1-25-85	Revised Quantities for Item No. 602.0600 Per C.O. No. 1.
12-31-84	Revised Quantities for Item Nos 206,5000, 206,8000, 602.0600, & 611.0100 Per Addendum No. 1.
DATE	REVISION
STATE OF HAWAII DEPARTMENT OF TRANSPORTATION LAND TRANSPORTATION FACILITIES DIVISION INDEX TO DRAWINGS & ESTIMATED QUANTITIES HANAMAULU VIADUCT HANAMAULU-AHUKINI CUTOFF ROAD Ahukini Road to Kauai Hardwoods PROJECT NO. F-051-1(4)	
SCALE: NONE DATE: SEPT., 1984 SHEET NO. 5-1 OF 541 SHEETS

HANAMAULU VIADUCT
HANAMAULU-AHUKINI CUTOFF ROAD
Ahukini Road to Kauai Hardwoods
PROJECT NO. F-051-1(4)

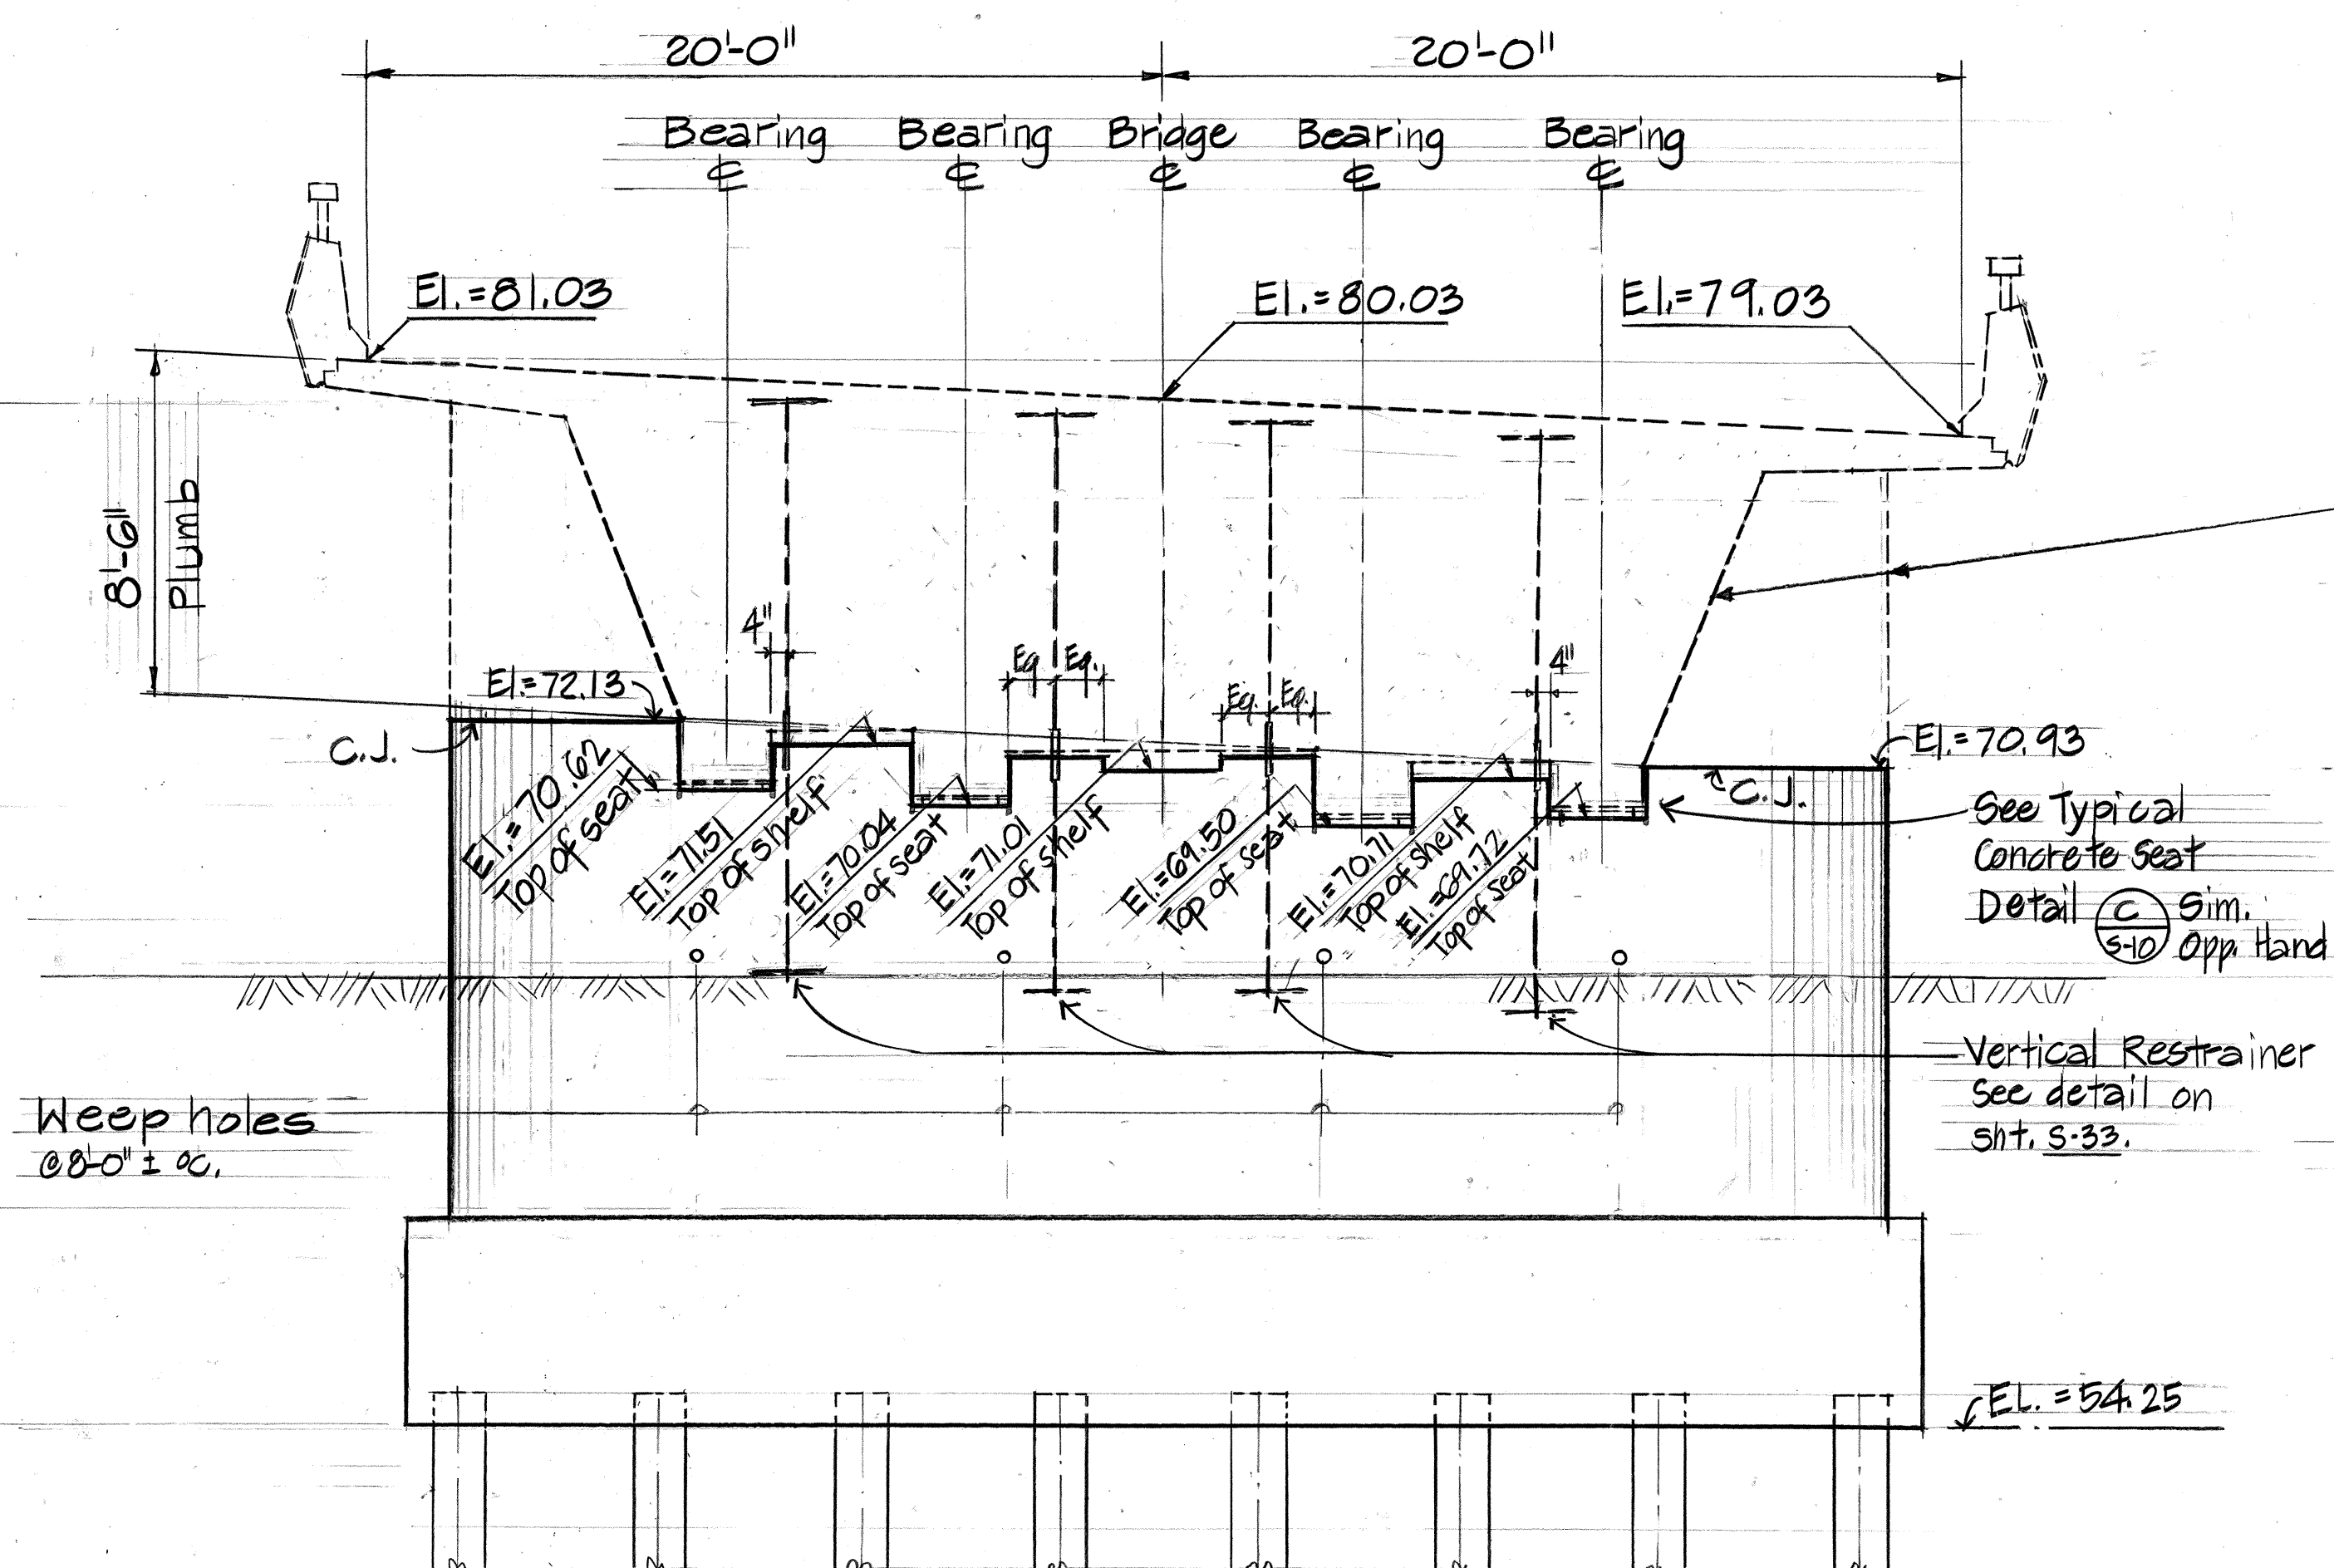
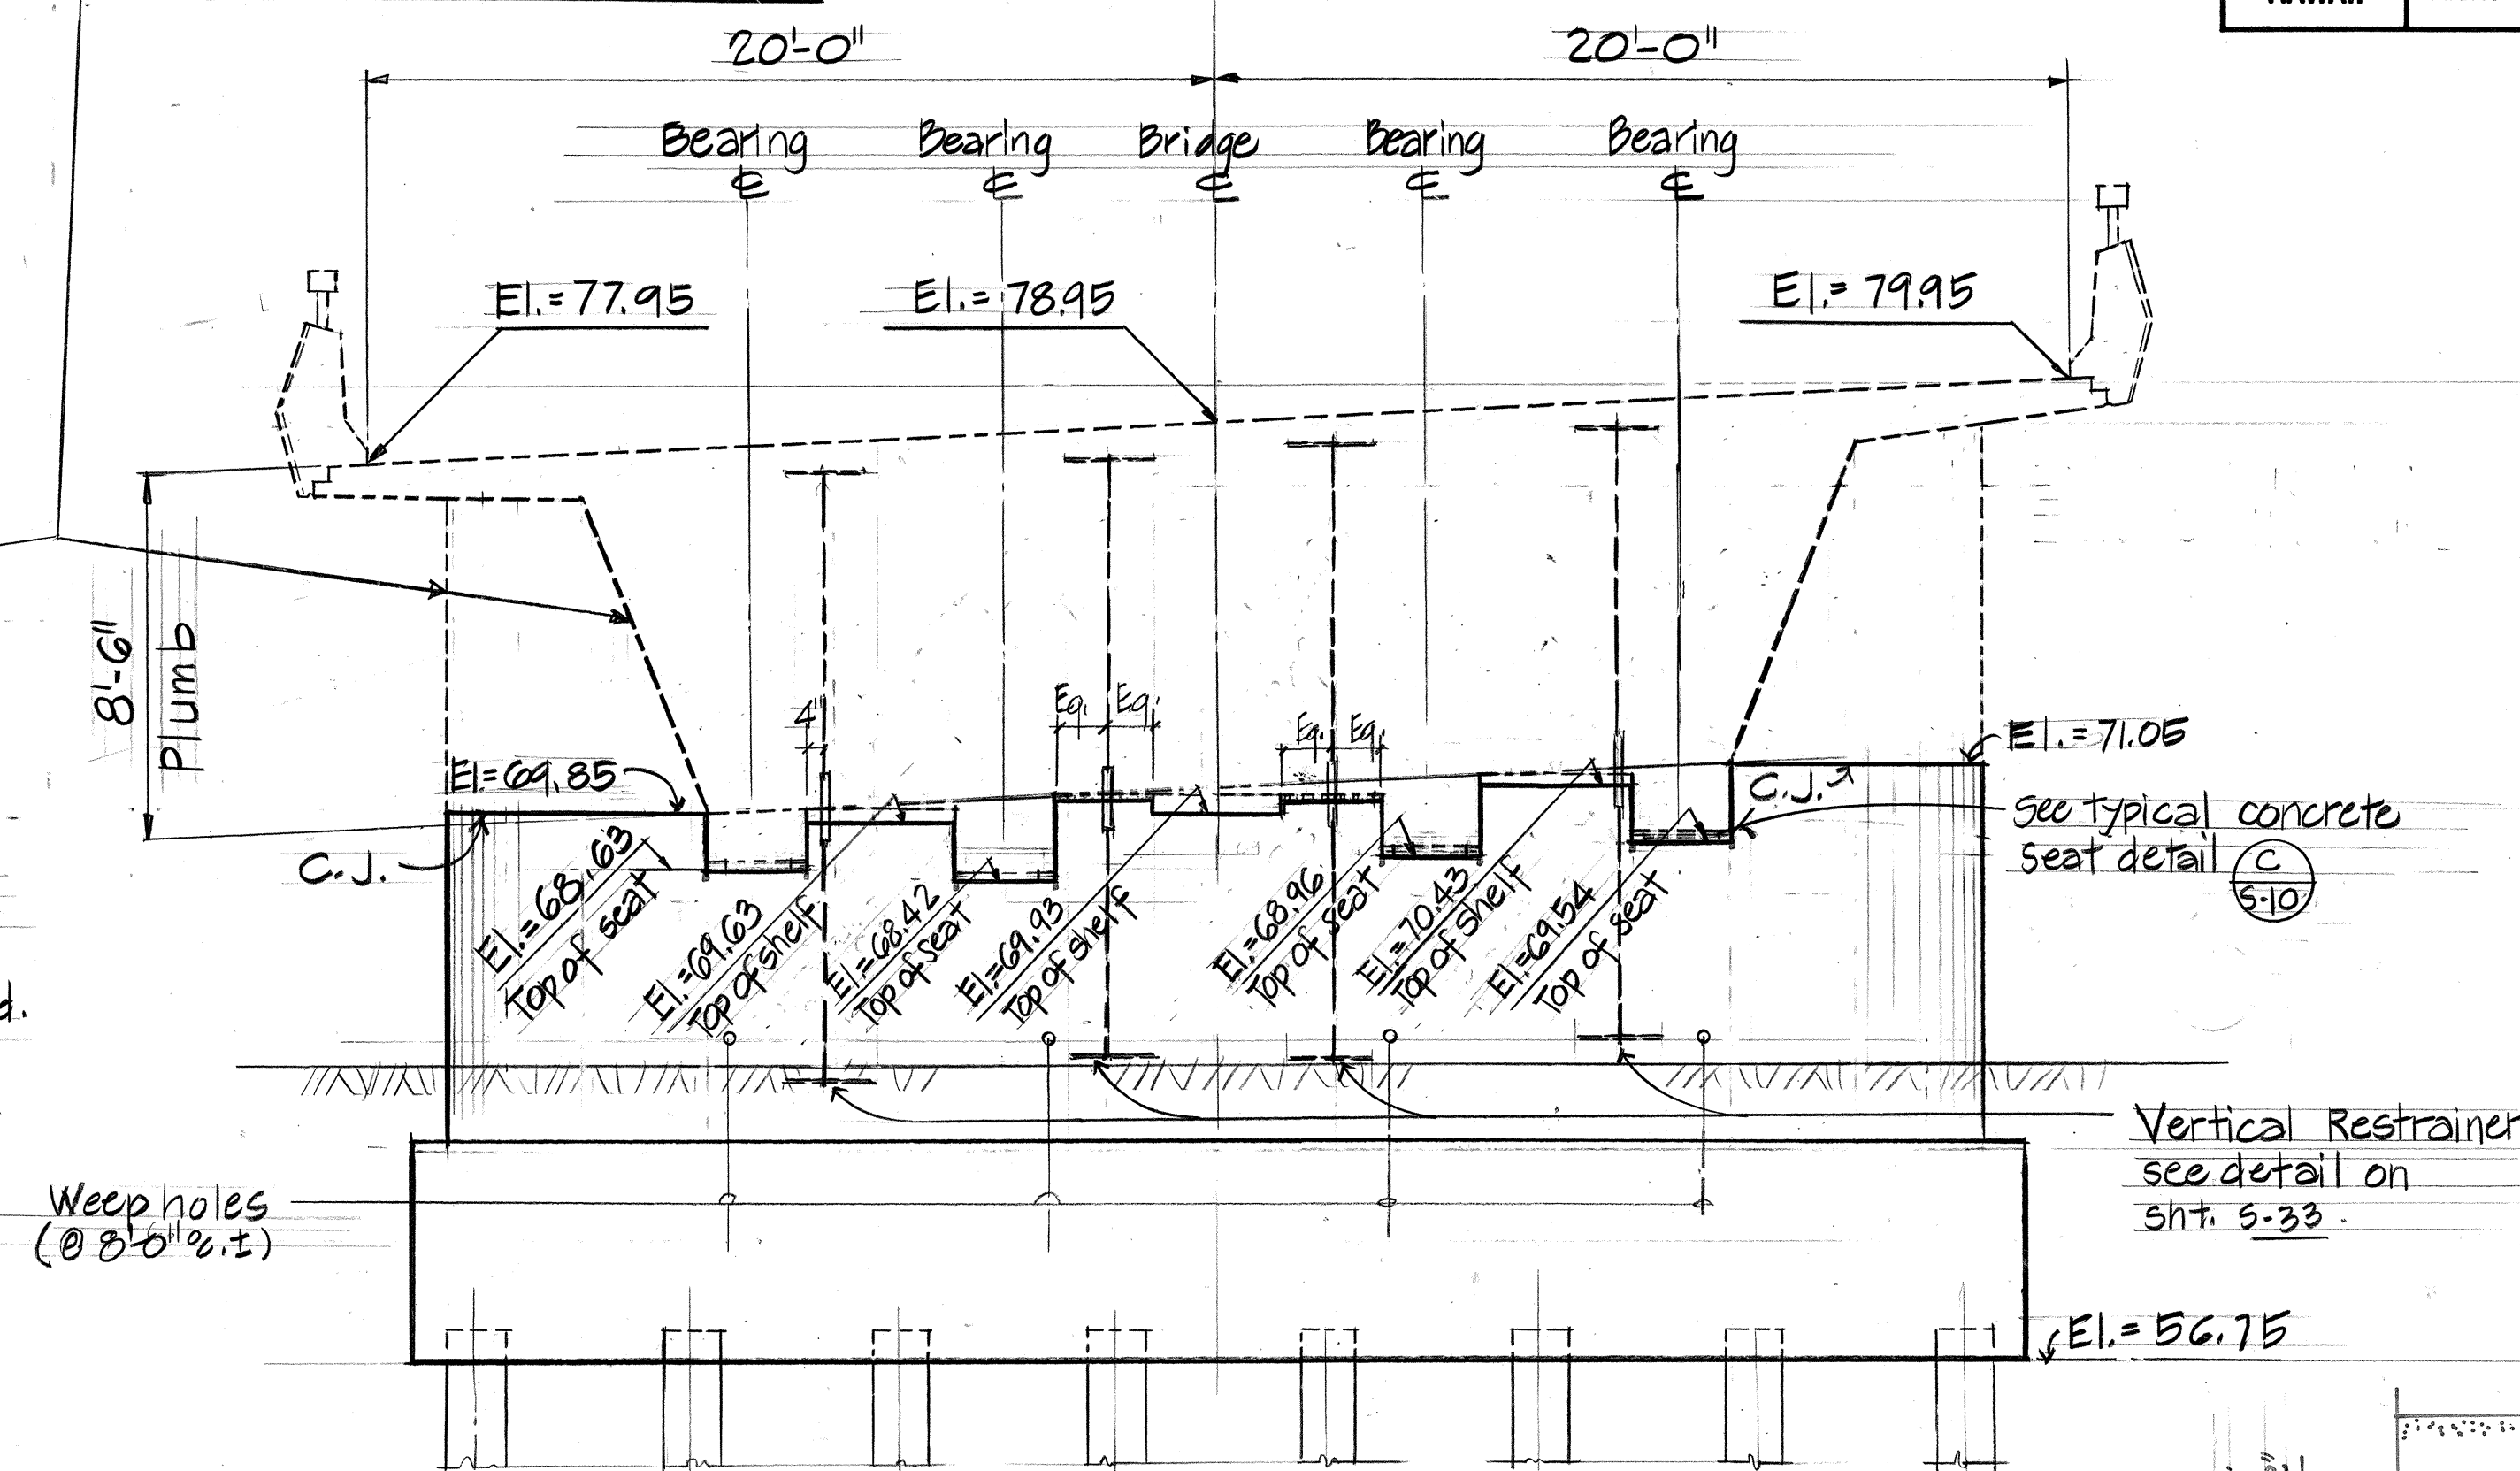
DATE	REVISION
12-31-84	Added Elev. to Lt. & Rt. Construction Joints on Details (A) & (B) Per Addendum No. 1. S-10 S-10
STATE OF HAWAII DEPARTMENT OF TRANSPORTATION HIGHWAYS DIVISION LIHUE AND KAPAA ABUTMENTS, ELEVATIONS, BEARING SEATS HANAMAULU VIADUCT HANAMAULU-AHUKINI CUTOFF ROAD Ahukini Road to Kauai Hardwoods PROJECT NO. F-051-1(4) SCALE: AS SHOWN DATE: SEPT, 1984 SHEET No. S-10 OF 5-41 SHEETS

TYPICAL PIER DETAIL (E)
Not to scale: (S16)

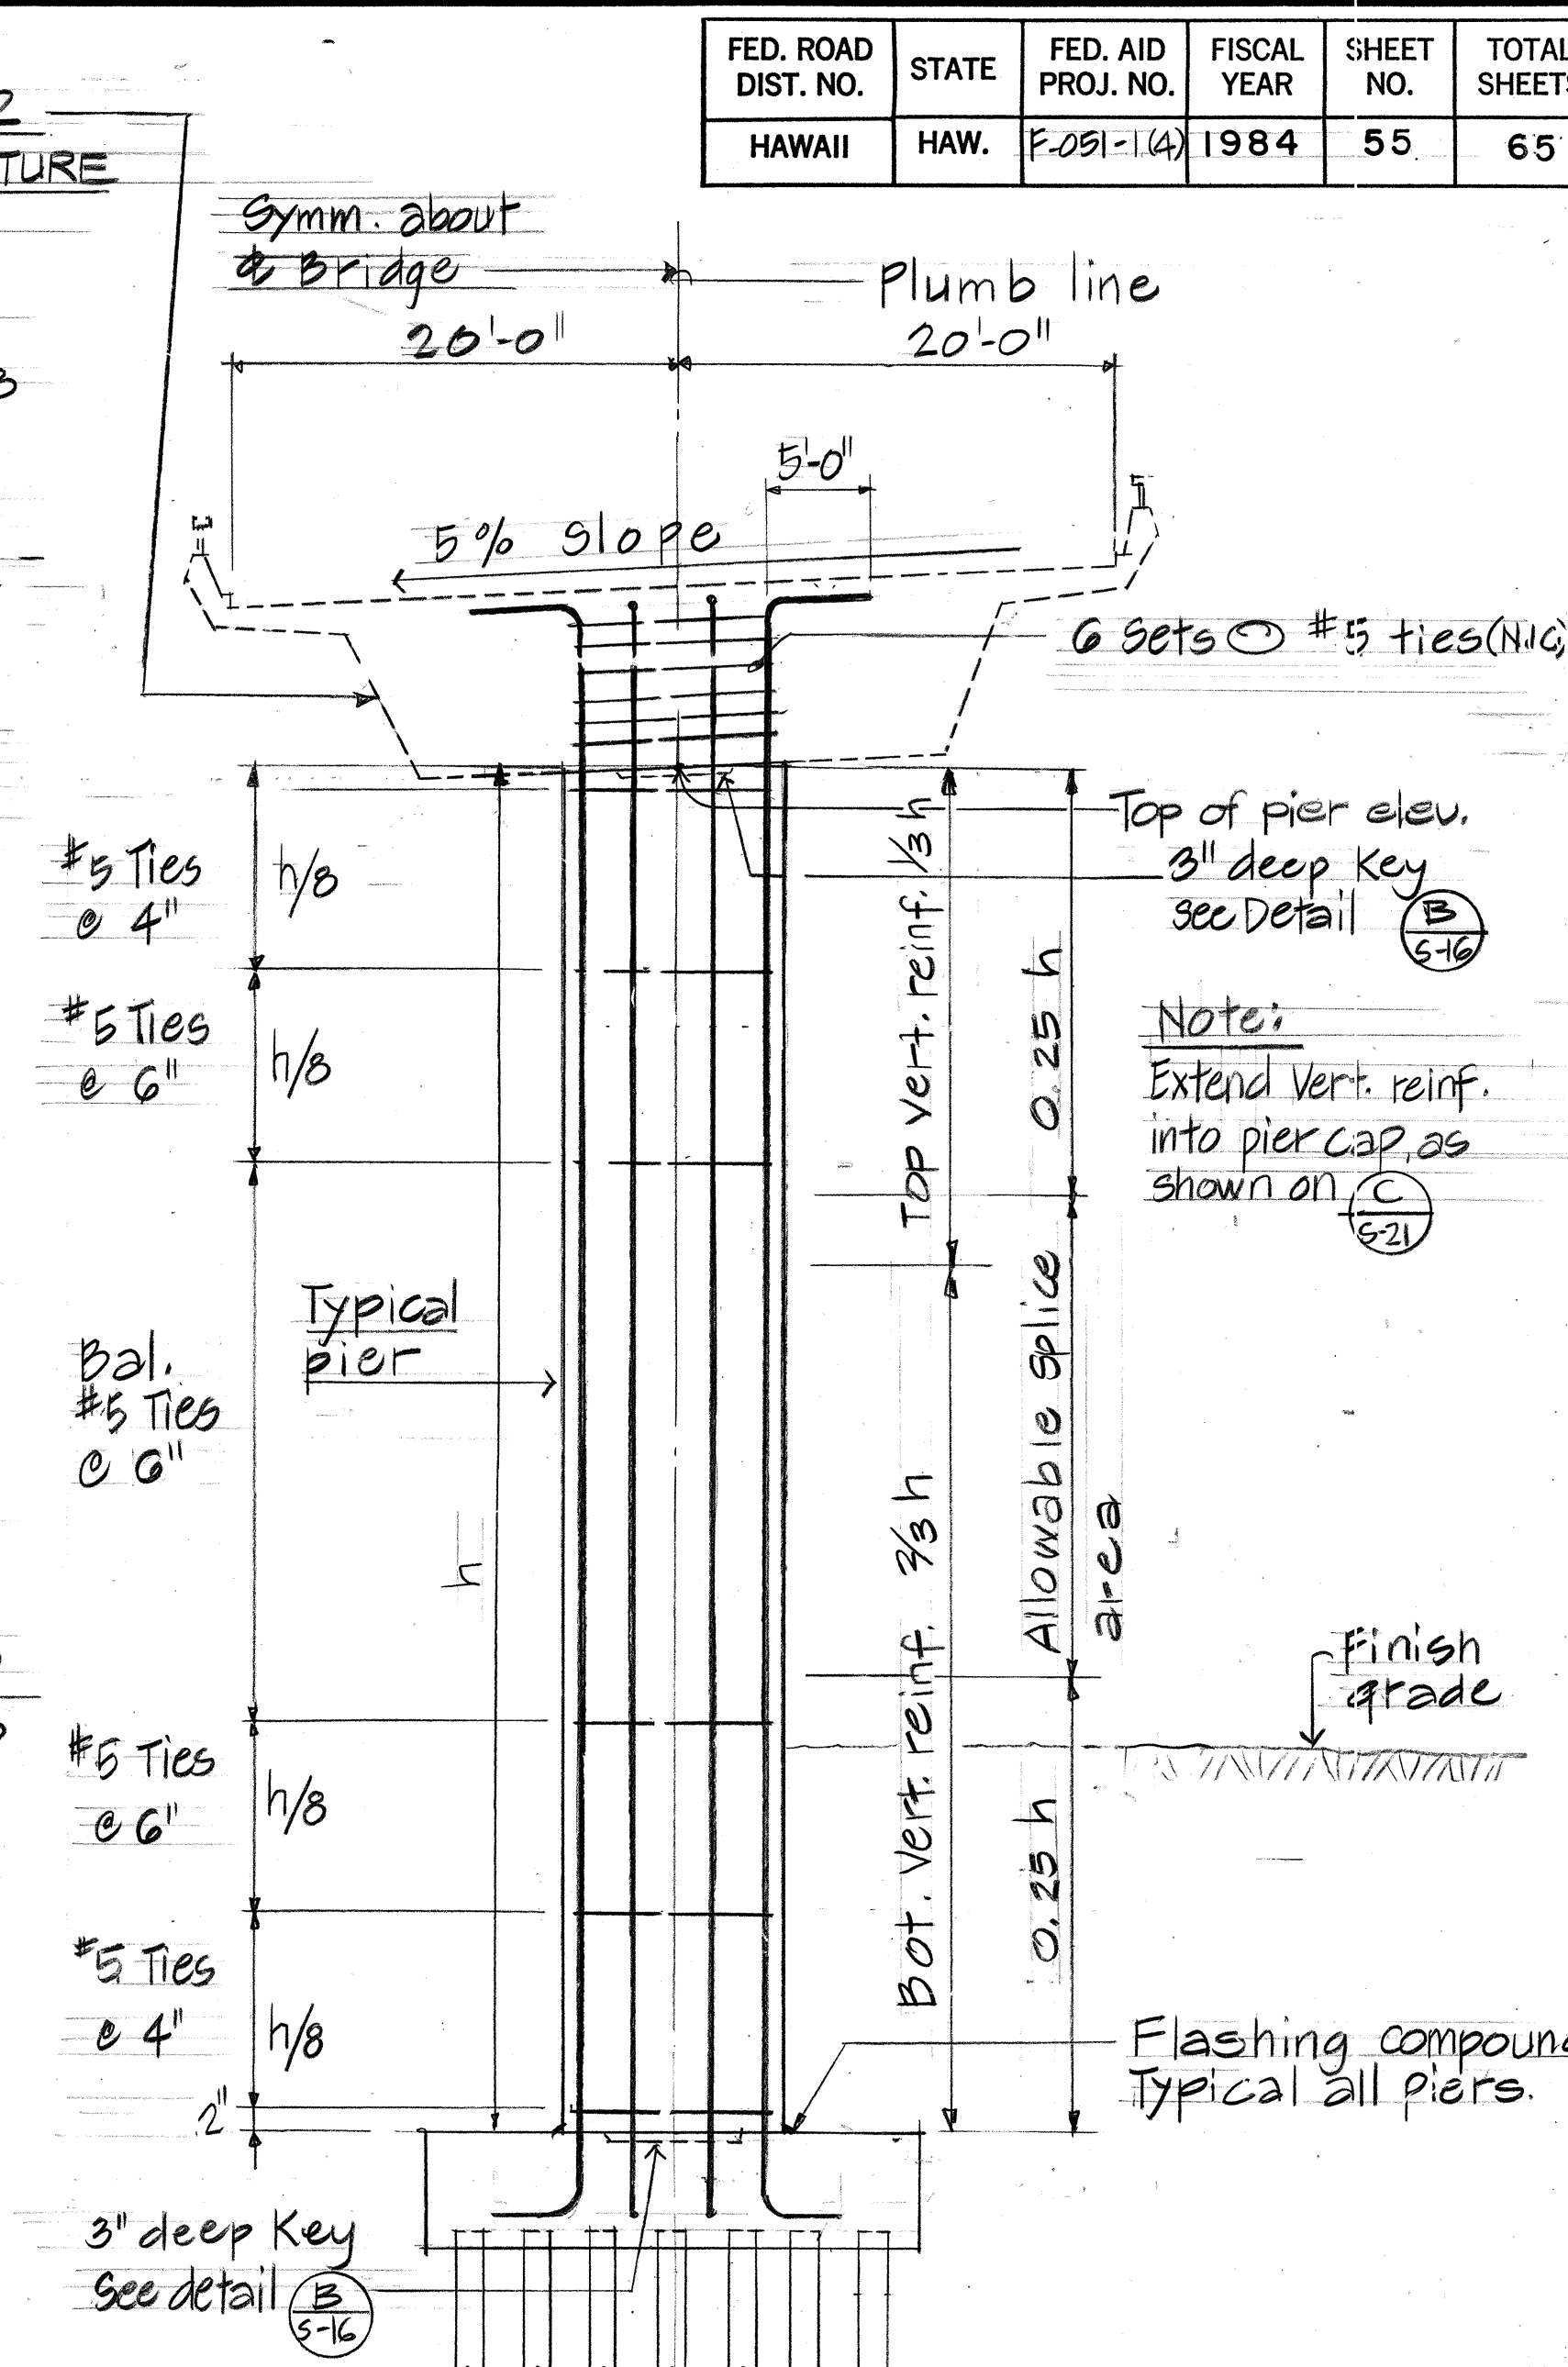
1-25-85	Revised Pier shaft tie spacing from 12" to 6" in Detail E/S 16
12/31/84	Revised D/S 16
DATE	REVISION
